**PLANNING ASSESSMENT REPORT FOR  
ORIGINAL CONCEPT APPROVAL  
(D/2015/966)**

**57 ASHMORE STREET AND  
165-175 MITCHELL ROAD ERSKINEVILLE**

**DEVELOPMENT APPLICATION: 57 ASHMORE STREET AND 165-175 MITCHELL ROAD ERSKINEVILLE****FILE NO:** D/2015/966**DEVELOPMENT APPLICATION NO:** D/2015/966**SUMMARY****Date of Submission:** 9 July 2015

Figure 32: Locations of non-compliances with the height control (greatest non-compliances in Blocks C, E and F shown in purple, with minor non-compliance in Block H circled in blue)

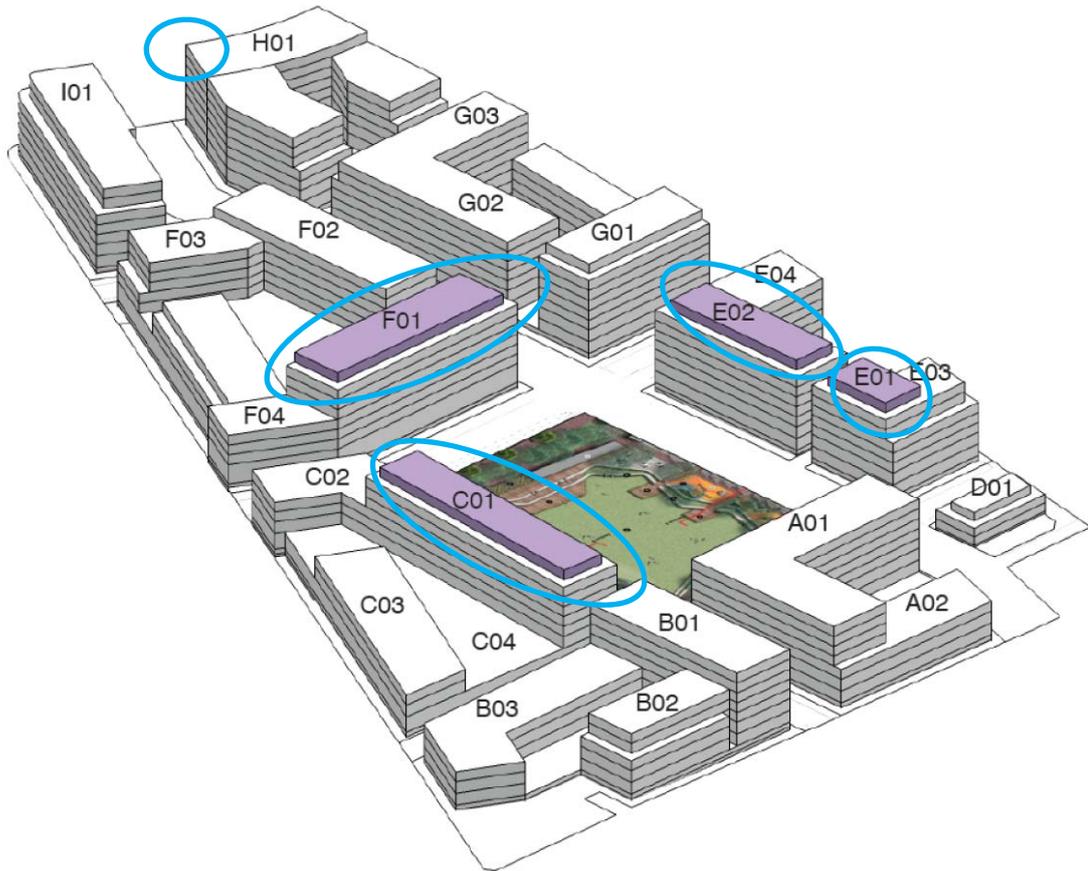
50. The most significant breaches are highlighted in purple and occur in segment C01 in Block C, segments E01 and E02 in Block E, and segment F01 in Block F. The fifth, and most minor breach, occurs in Block H.

Figure 33: Minor height non-compliance on Block H (0.25m, 1% variation)

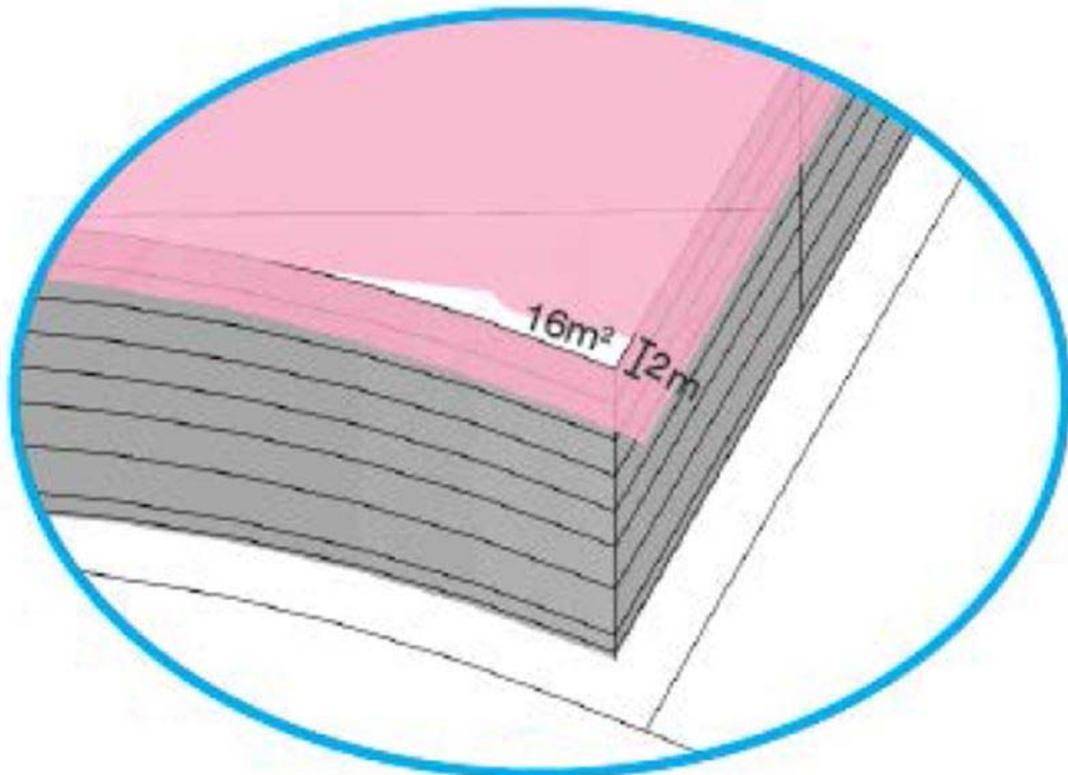
- (d) Block F, segment F01 (variance is partially 2.55m (9.44%) and partially 4.55m (18.2%)); and
  - (e) Block H, segment H01 (maximum variance is 0.25m (1%)).

Figure 34: Proposed height non-compliances at Block F

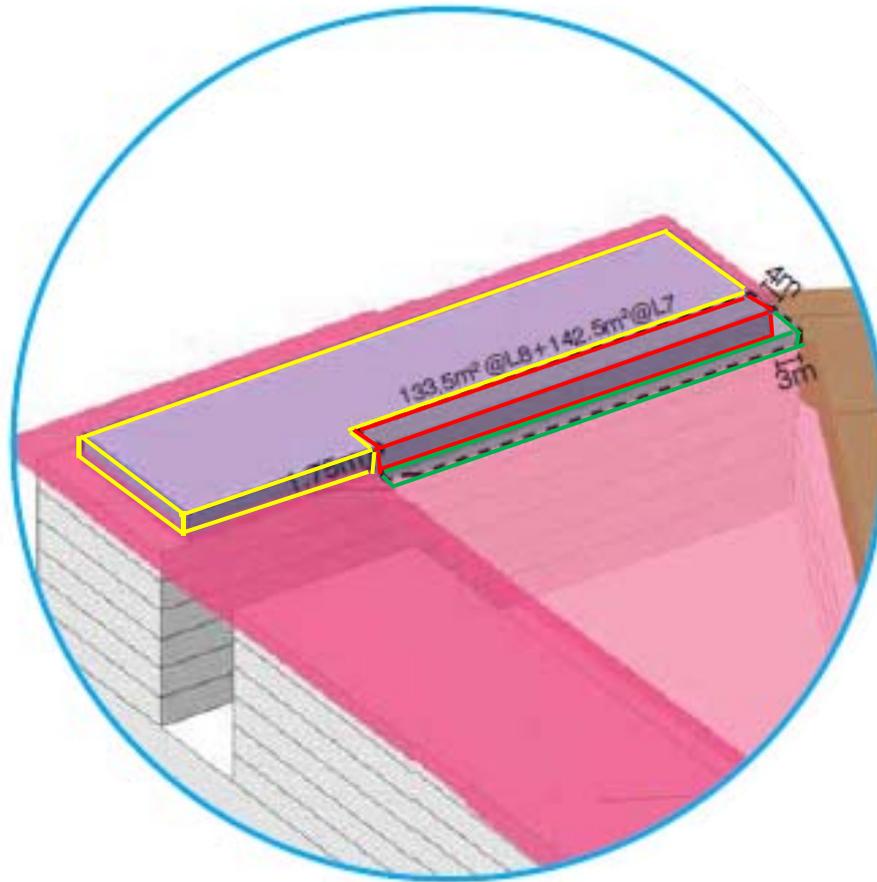
- 55. As indicated above, Level 8 in Segment F01 on Block F is proposed to have a maximum height of 29.55m. It straddles the boundary between two height controls (27m and 25m), which results in three separate non-compliances which are illustrated in Figure 34 below. Specifically, the proposed non-compliances in Segment F01 on Block F are:

- (a) Level 8, 4.55m above the 25 height control, which equates to a variation of 18.2% (outlined in red);
  - (b) Level 8, 2.55m above the 27m height control, which equates to a variation of 9.4% (outlined in yellow); and

- (c) Level 7, 1.45m above the 25m height control, which equates to a variation of 5.8% (outlined in green).

Figure 43: Proposed building envelope for Block C

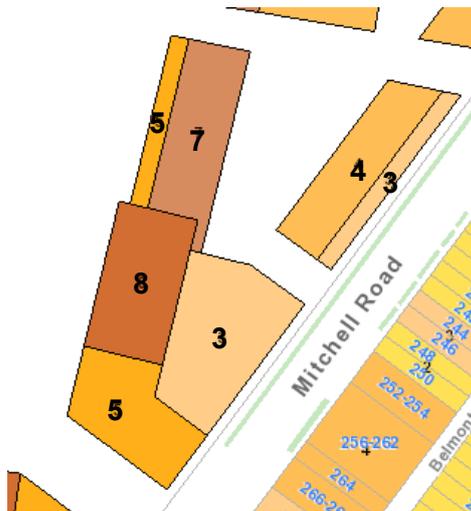
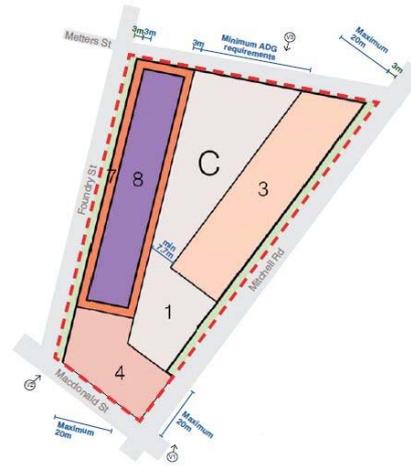
75. The proposed building envelope for Block C does not comply with the maximum height control of 27m, as the building proposed for the western portion of the site is proposed to have a maximum height of 29.84m (10.5% variation). Non-compliance with the height control is considered acceptable in this location for the reasons outlined elsewhere in this report.

76. Block C generally complies with the height in storeys and street wall height controls, except in the north western corner of the site where eight storeys with a seven storey street wall height is proposed. Seven storeys with a five storey street wall height is specified within the controls for the site.

77. The proposed eighth storey is arising from the reallocation of floor space from Block B to retain the Weeping Hills Fig Trees on that site. Eight storeys is consistent with the maximum height permitted in the same block immediately to the south, and the Ashmore specific provisions of the DCP indicate that an eighth storey is suitable in this location in its consideration of where bonus floor space for design excellence may be located (refer to Figure 44).

- 78. While the proposal does not comply with the five storey street wall on the north western frontage, the proposed seven storey street wall height is acceptable as it will provide a consistent street wall height along the western frontage of Block C, and a consistent street wall height around the park (refer to Figures 39, 48, and 50).
- 79. In light of all of the above, the proposed building envelope for Block C is recommended for approval without amendments.

Figure 50: Proposed building envelope for Block F

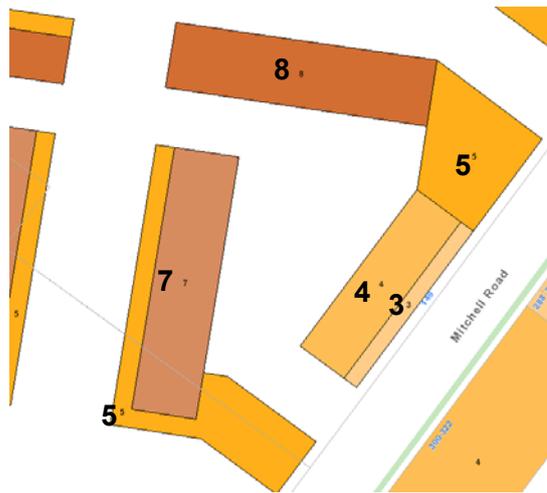
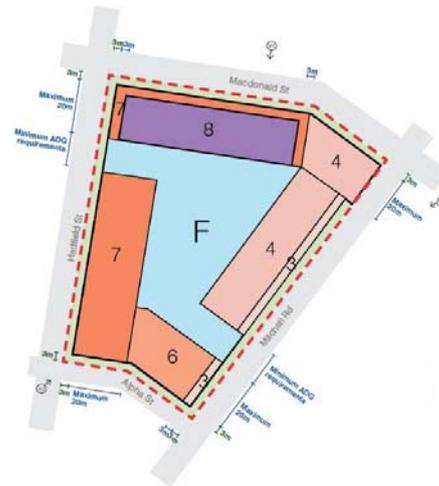
87. The proposed building envelope for Block F does not comply with the maximum height control of 27m, as the eight storey building proposed in the northern portion of the block is proposed to have a maximum height of 29.55m (9.4% variance). Part of the eighth storey is also located on land subject to a maximum height control of 25m, resulting in a variation of 18.2% in this location. Non-compliance with the height control in this location is considered acceptable for the reasons outlined elsewhere in this report.

88. The proposal generally complies with the height in storeys control, except for the south eastern corner of the site on the corner of Mitchell Road and the future Alpha Street. This portion of the site is subject to a five storey height control; however, a six storey building is proposed.

89. The proposed sixth storey is acceptable. With a maximum height of 23.63m it is located well below the maximum height control of 25m. It will also provide a transition in height from the three and four storey buildings proposed in the northern portion of the site fronting Mitchell Road, to Block I and the existing Sydney Park Village (seven storeys). It is also noted that the Ashmore specific provisions of the DCP indicate that an sixth storey is suitable in this location in its consideration of where bonus floor space for design excellence may be located (refer to Figure 51).

90. While the western building complies with the seven storey height of buildings control, it does not comply with the five storey street wall height requirement fronting Kooka Walk. This is not acceptable, as the DCP requires a predominant five storey street wall height in the vicinity of the southern part of Kooka Walk, which is envisaged as a green link for pedestrians and cyclists. While higher street walls are acceptable in the northern part of Kooka Walk, which is adjacent to the park, the southern part of Kooka Walk has buildings on both sides. Here, higher street wall heights are likely to reduce the sense of openness to the sky and the human scale will be diminished. Although the Ashmore specific provisions of the DCP recommends an upper level setback of 4m, it is considered that a 3m setback will suffice if applied to Blocks F, G, H and I where they front Kooka Walk. This will result in a building separation of 38m between the upper levels.

91. In light of the above, a condition of consent is recommended requiring the building envelope of Block F to be amended as follows:
  - (a) A five storey street wall height is to be provided on the western facade of the southern building facing Kooka Walk, and the upper levels are to be setback a distance of three metres from the western face of the building.

Figure 55: Proposed building envelope for Block H

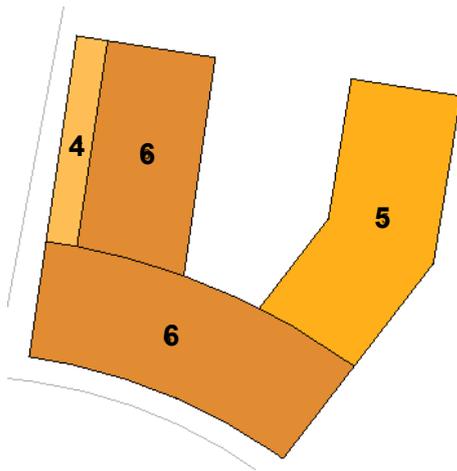
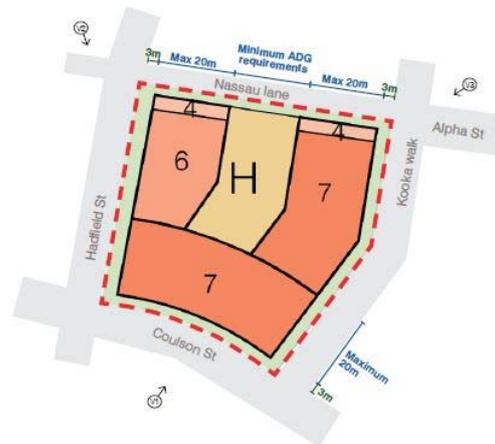
101. Block H is contained entirely within the maximum height plane. It does not comply with the maximum height in storeys control in the north eastern portion of the building, where a maximum of five is permitted but seven is proposed, or in the southern portion where six is permitted but seven is proposed. It complies with the height in storeys control in the north western portion of the building, but does not comply with the requirement to provide a four storey street wall height fronting Hadfield Street.

- (c) a four storey street wall height is to be provided on the western facade of the building facing Hadfield Street, and the upper levels are to be setback a distance of three metres from the western face of the building.

Figure 57: Proposed building envelope for Block I

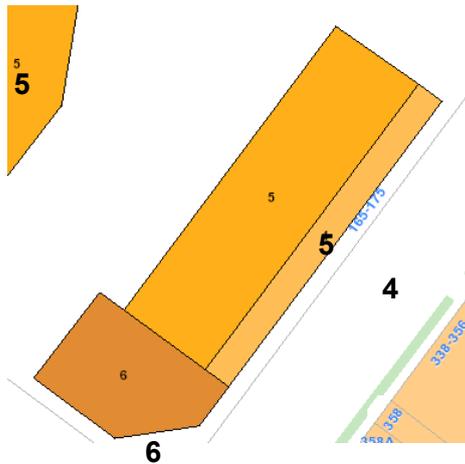
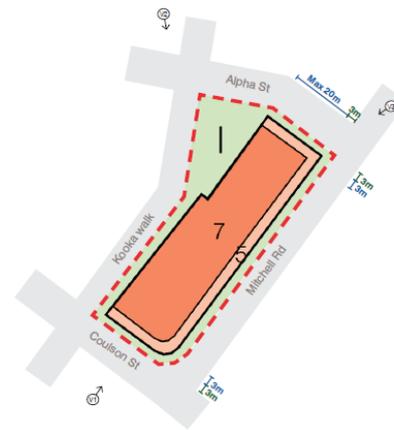
106. Block I is contained entirely within the maximum height plane. It does not comply with the maximum height in storeys control however, which predominantly permits five storeys, but also allows six storeys in the southern portion fronting Coulson Street. It also does not comply with the requirement to provide a four storey street wall height to Mitchell Road, where a five storey street wall height is proposed.

Figure 58: Building separation distances

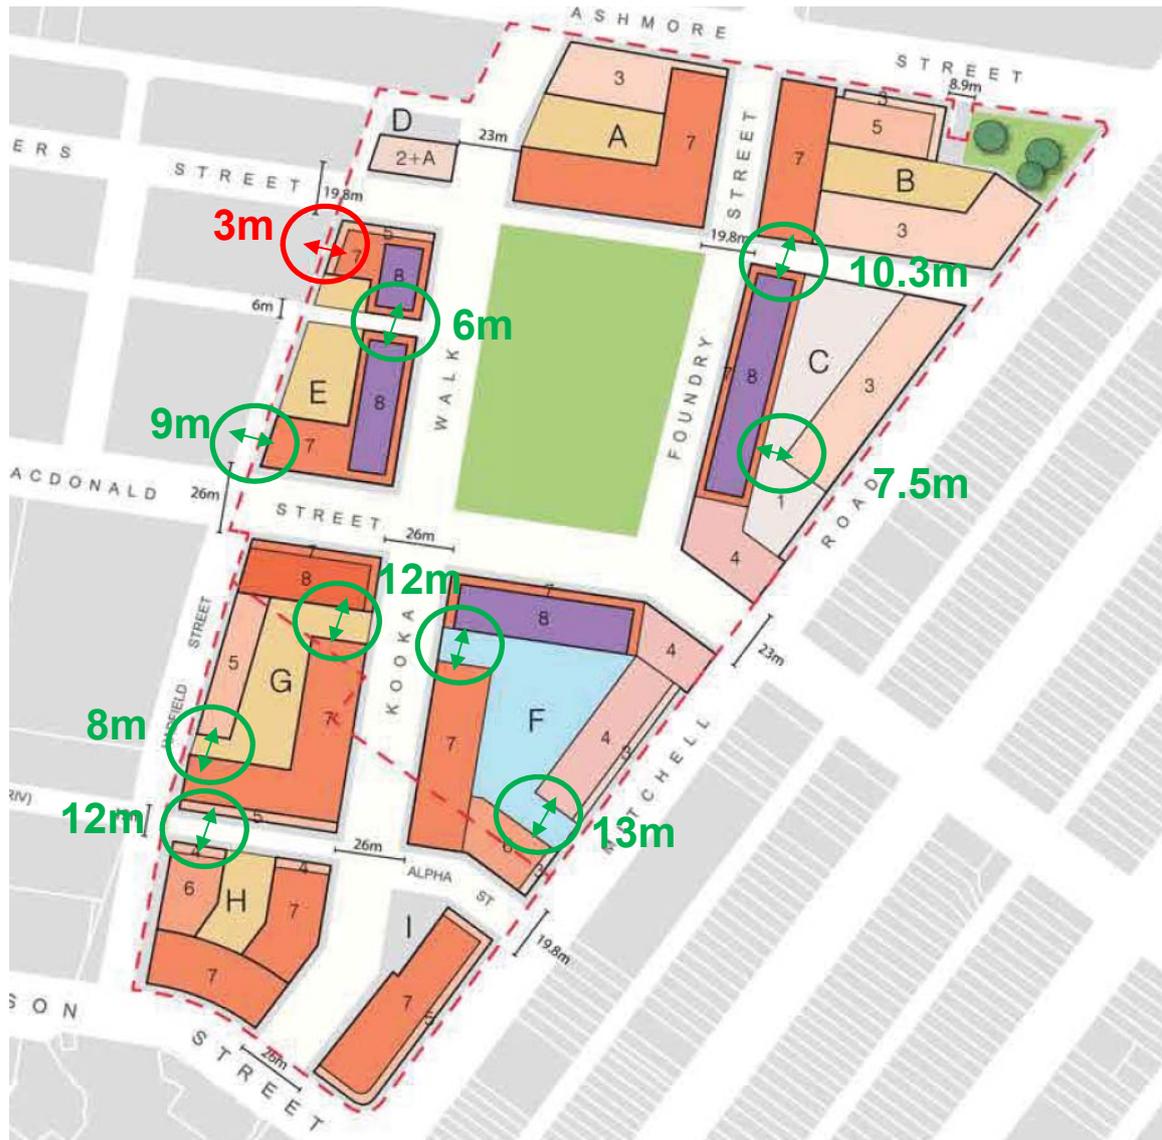
118. As shown in Figure 58 below, there is generally a high degree of compliance with the building separation requirements. However, the building separations identified above are less than that which is required between habitable rooms and balconies. This will require the Stage 2 DAs to ensure the interface between buildings in these locations is between habitable rooms and non-habitable rooms, solely between non-habitable rooms, or rooms to blank walls as required.

119. The 3m separation distance between the northern building of Block E has the potential to result in non-compliances with the minimum separation requirements between buildings. This has arisen due to the CSPC approval of D/2014/1703 at 1A Coulson Street, which has approved car park access with a blank wall hard up against the boundary on Ground Level, areas of open space hard up against the side boundary on Level 1, and windows to habitable rooms and balconies with only a 3.375m setback on Levels 1-7. The Level 1 plan is provided for illustrative purposes in Figure 59 below.
